MOUNT OWEN CONTINUED OPERATIONS PROJECT

Clarification of Project and Assessment
Findings Report

**Re: Mount Owen Continued Operations Project – EIS Figure amendment clarification –
Figure 2.15 Hebden Road Upgrade Works**

FIGURE 2.15

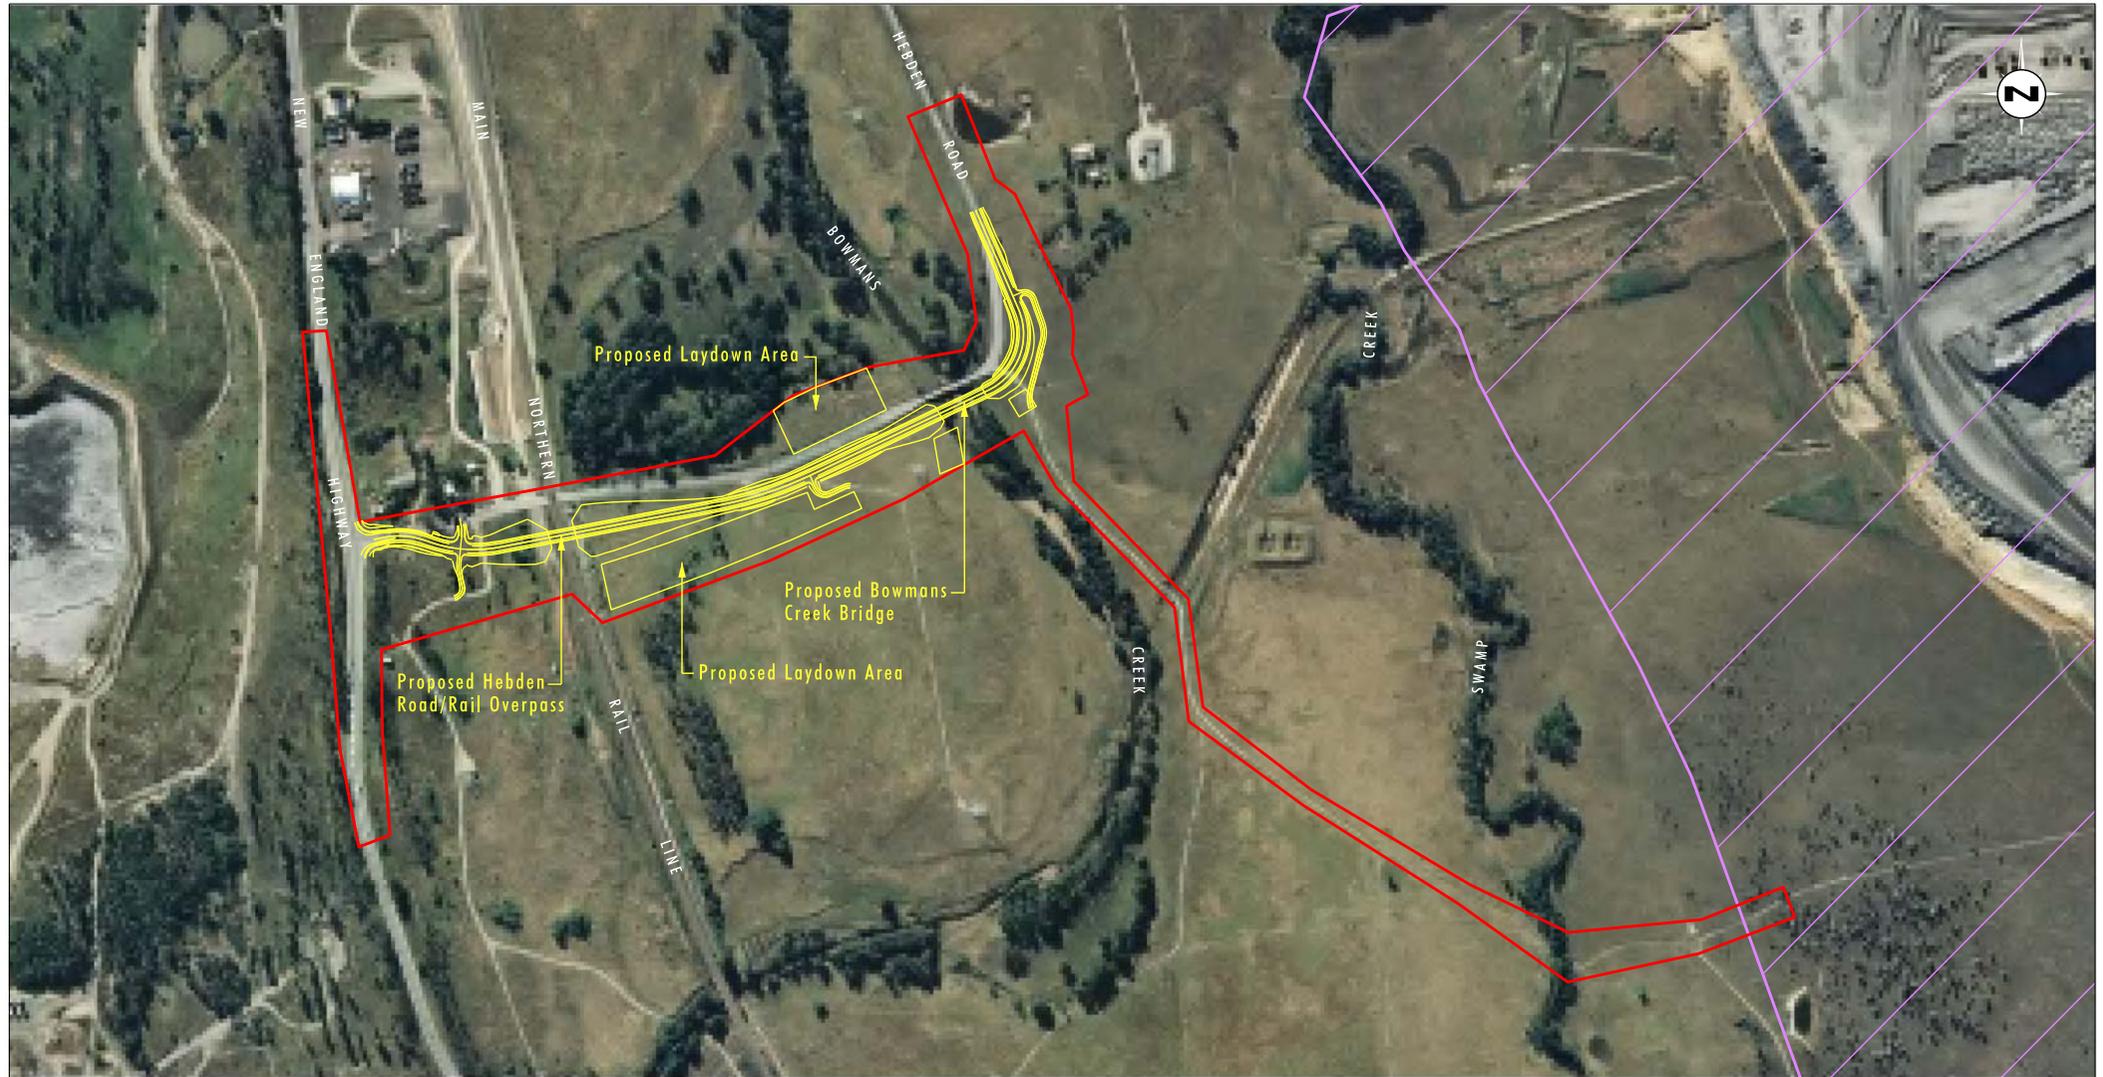
The details provided in Figure 2.15 of the EIS erroneously included the relevant figure layers for the previous design option in addition to the currently proposed works and does not accurately reflect Project related works in this area. Accordingly, this figure has been revised and is attached. It is requested that the DPE assessment report refer to the attached corrected figure and this be reflected in relevant conditions of consent for the Project.

Accordingly, the proposed design was revised to remove all works to the existing intersection, apart from the works associated with the approach to the intersection on Hebden Road, associated with the proposed works described above.

Figure 3.5
Final Landform

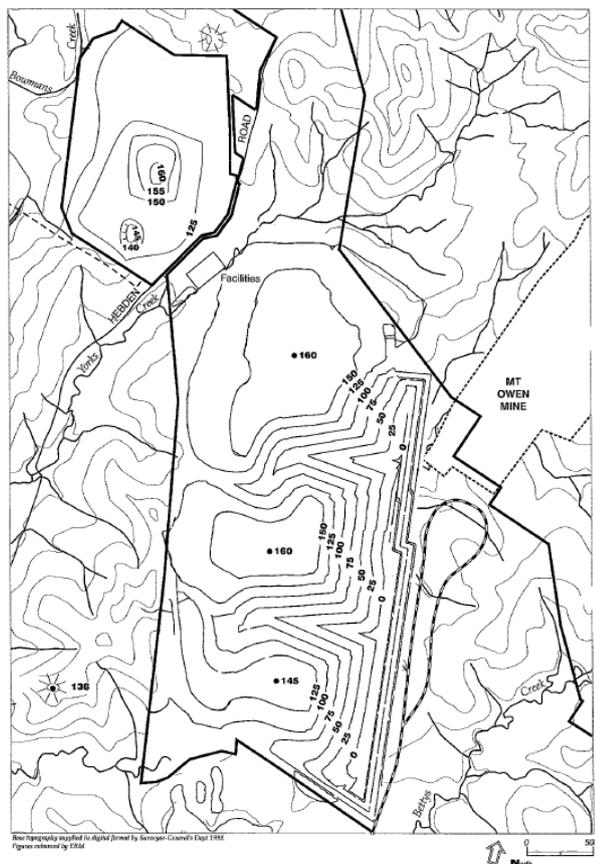
- 28 It is clearly apparent from these multiple references in the Ravensworth East EIS that a relatively large final void was approved at Ravensworth East as part of the original Ravensworth East Consent. With reference to Figure 3.5 above, we understand that the original final void was approximately 3.2 kilometres in length and 650 metres wide, covering an area of approximately 208 hectares.

Figure 6.3
Proposed Swamp Creek Diversion

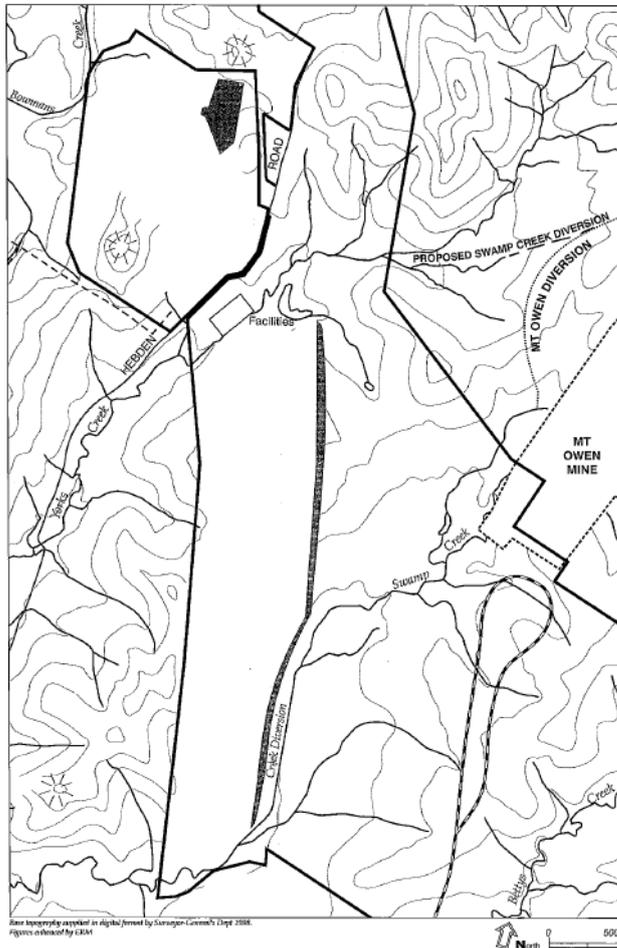
- 29 Separately, we also refer to Figures 6.3 and 6.4 of the Ravensworth East EIS which shows the location of the Proposed Swamp Creek Diversion to the north of the BNP. This is relevant as Condition 30 in the

30 On this basis, it is evident that the final void was contemplated to be in the proximity of the BNP area as there was identified a possibility for interactions between the Swamp Creek diversion and the final void.

FIGURE 1
Mount Owen Continued Operations Project Conceptual Final Landform

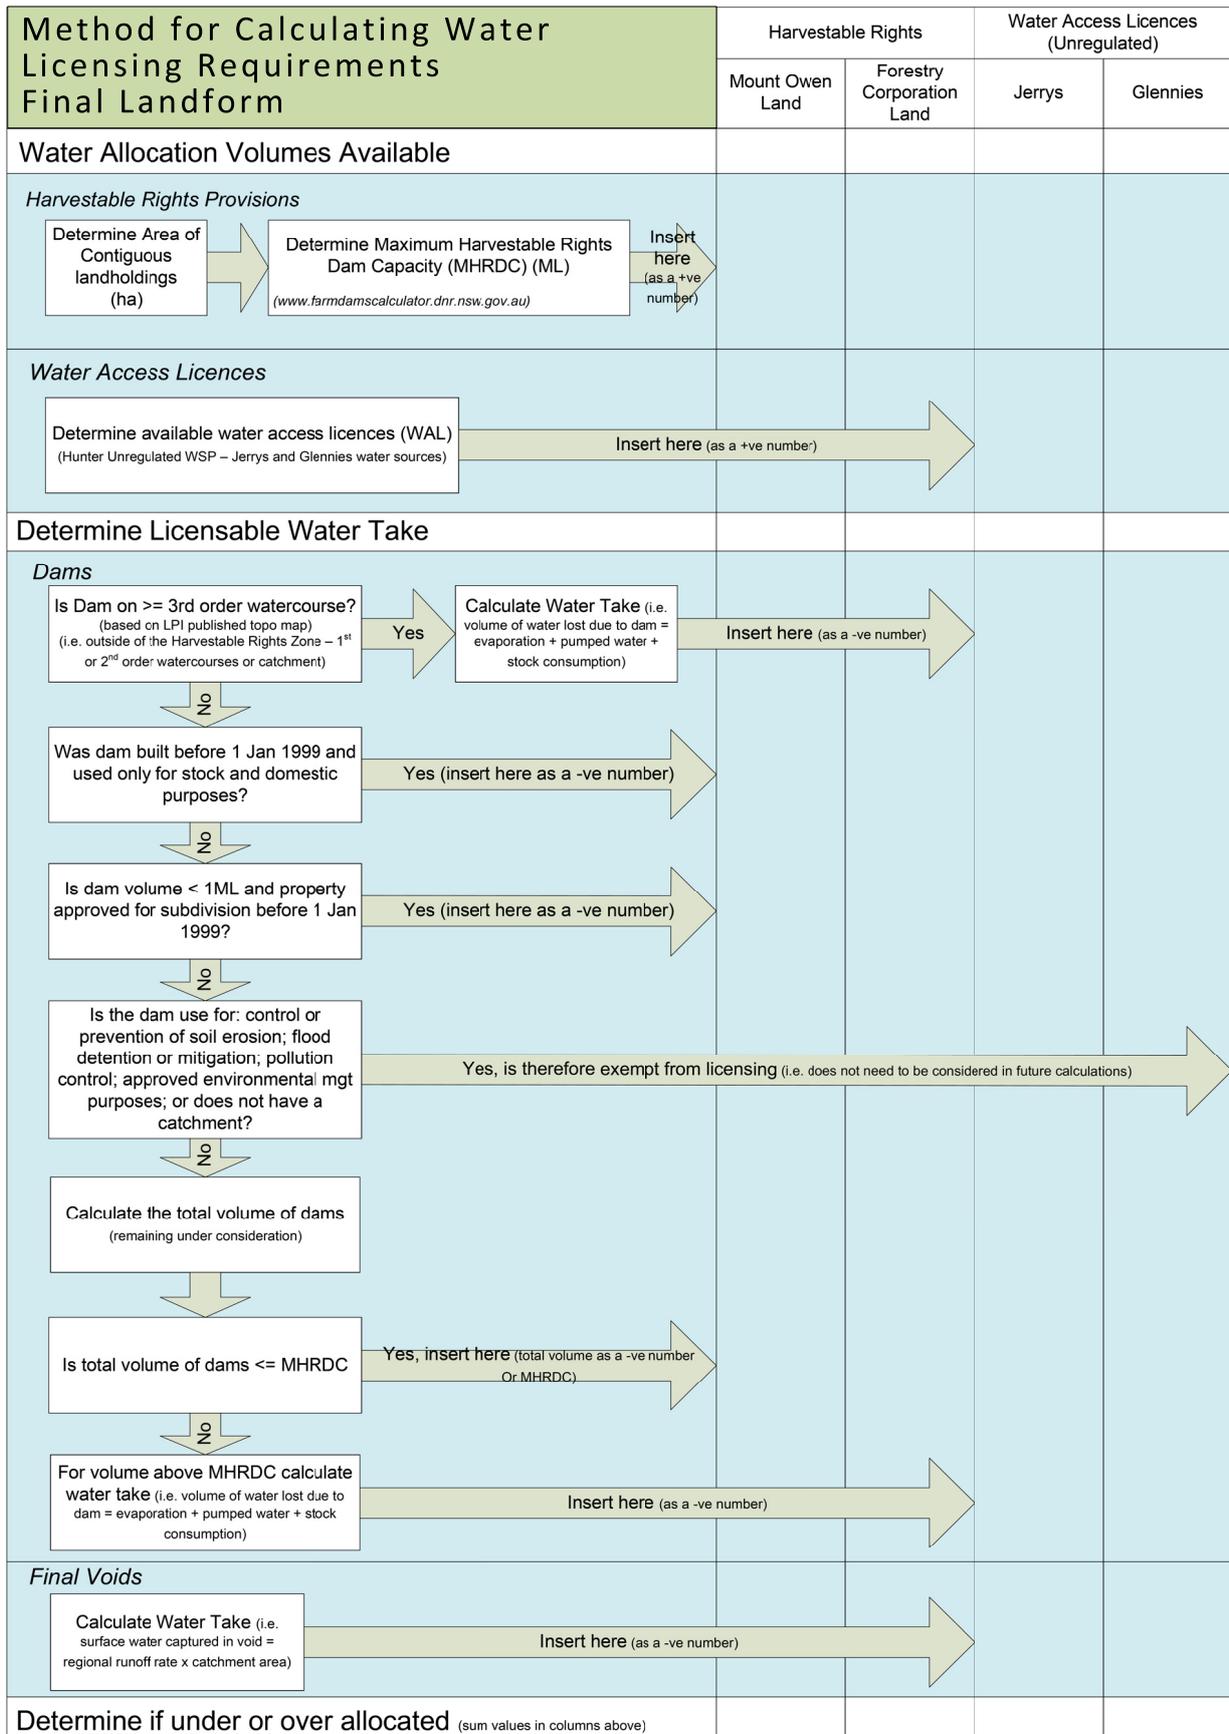
On this basis, we have further investigated potential final landform alternatives that may be necessary in order to meet water licence requirements if sufficient allocation is not available in the Glennies Water Source in the future. We provide the following as an example of how the final landform may be further optimised to reduce the catchment of the final void, but note that the detail of such an option would require further investigation and confirmation as detailed mine planning progresses, consistent with the intent of the draft approval condition outlined above. For example, there is potential to reduce the catchment area of the North Pit final void by up to approximately 170 hectares (i.e. from 471 hectares to 300 hectares). In this scenario, the area shaded in the attached proposed final landform figure (reproduced from our Response to the PAC Review) would need to be reshaped. If this option was adopted it would result in progressively reshaping of the southern portion of the overburden emplacement area. The area removed from the void catchment would be reshaped to flow to the east and a minor tributary of Main Creek, and direct water from the final landform into the Glennies water source.

FIGURE 5.6

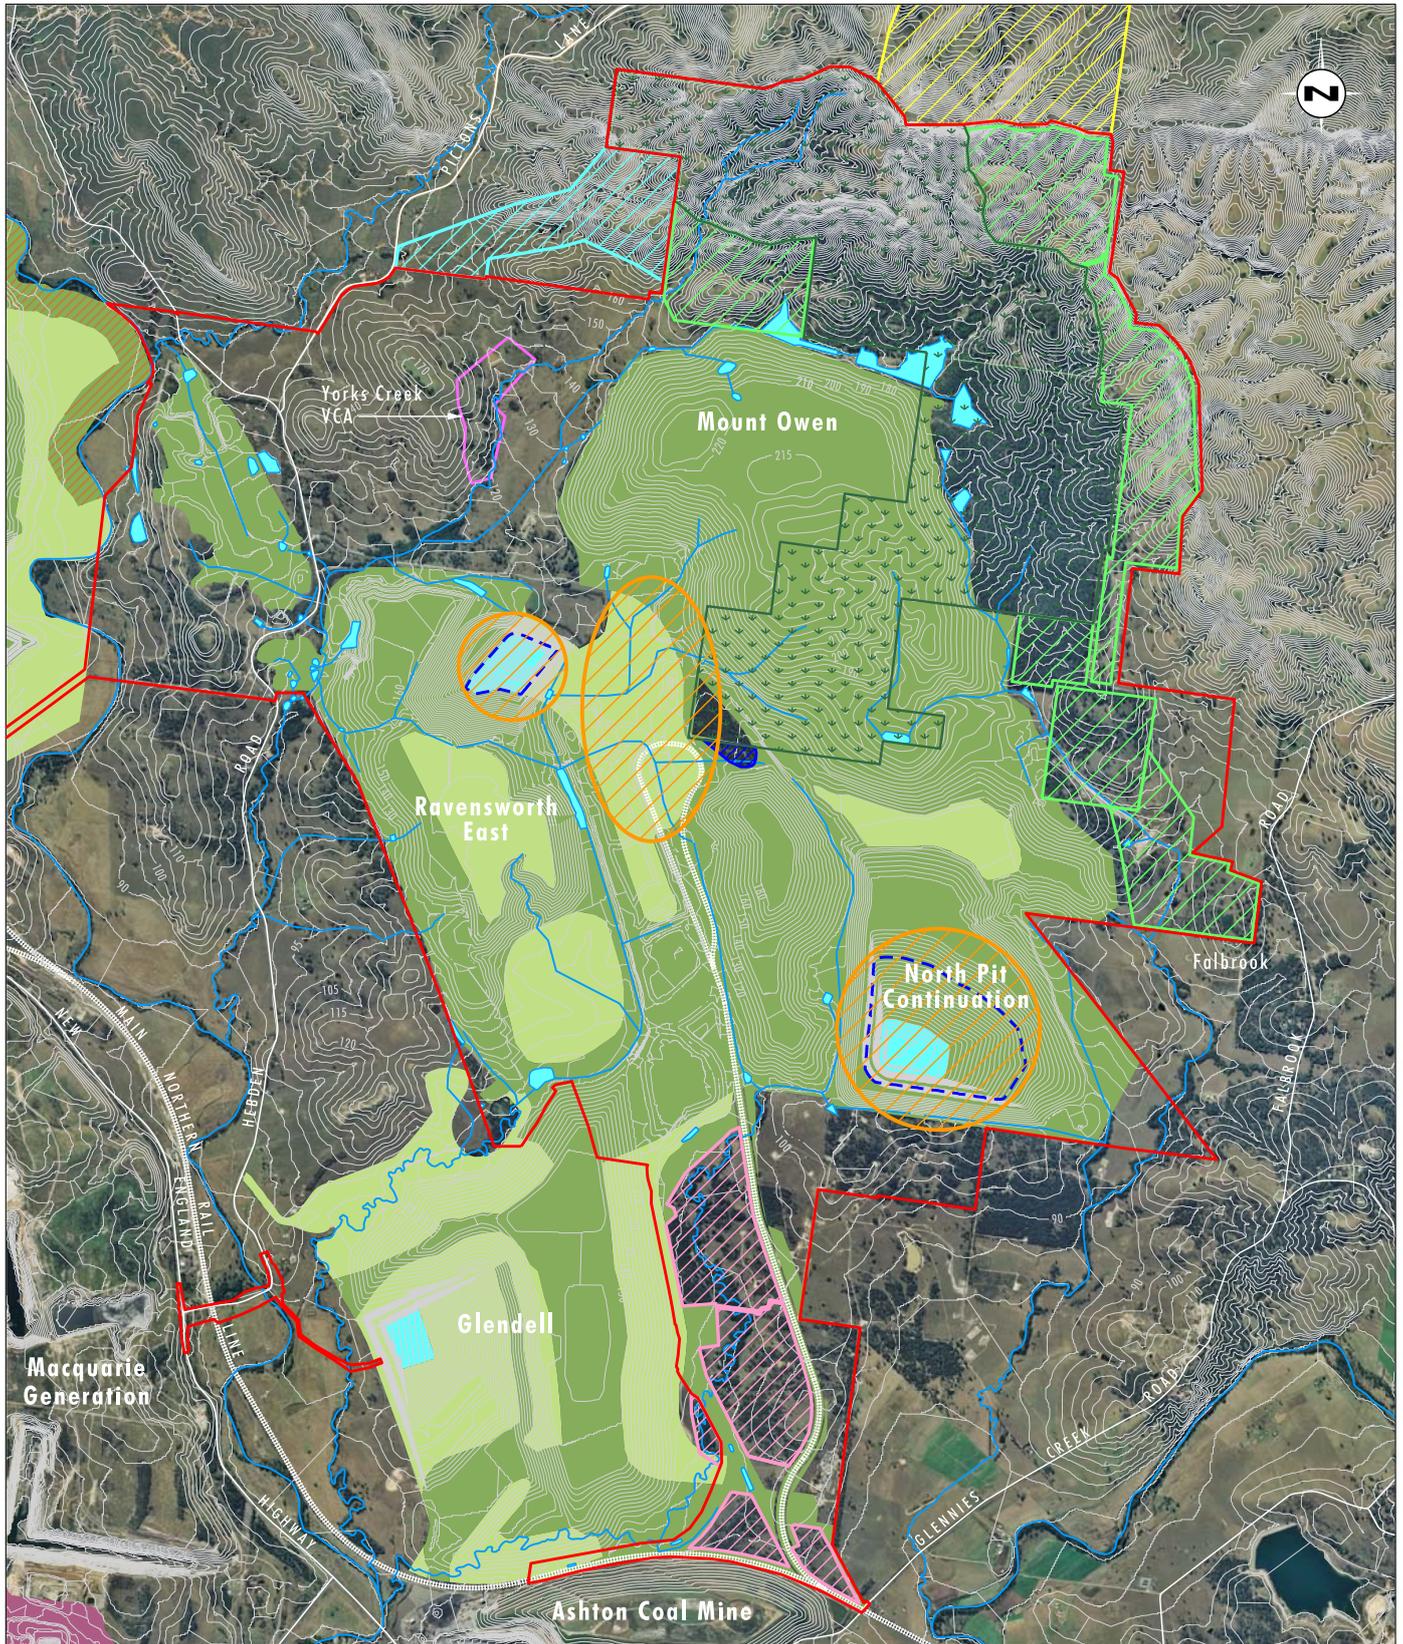
As can be seen from **Table C**, the conceptual rehabilitation strategy for the Project shown in **Figure 5.6** of the Response to PAC Review Report will result in significantly more woodland in the Ravensworth East development consent area than is currently approved. The area of woodland in the existing Mount Owen development consent area is also slightly larger than is currently approved and there will also be more woodland established in the Proposed Disturbance Area than is currently present.

The conceptual rehabilitation strategy shown in Figure 5.6 in the response to PAC Review Report has deliberately identified the areas which are most suitable for alternative land uses as being grazing land; this includes the existing mine infrastructure areas. The flatter infrastructure areas and final voids are the areas considered most likely to be the most suited to alternative land uses. The removal of infrastructure will only occur on the cessation of mining. The rehabilitation of voids and infrastructure areas will only commence following the cessation of mining. Should an alternative land use(s) be identified during the mine closure planning process, the detail regarding the locations where rehabilitation woodland is established in and around these areas can have regard to the likely
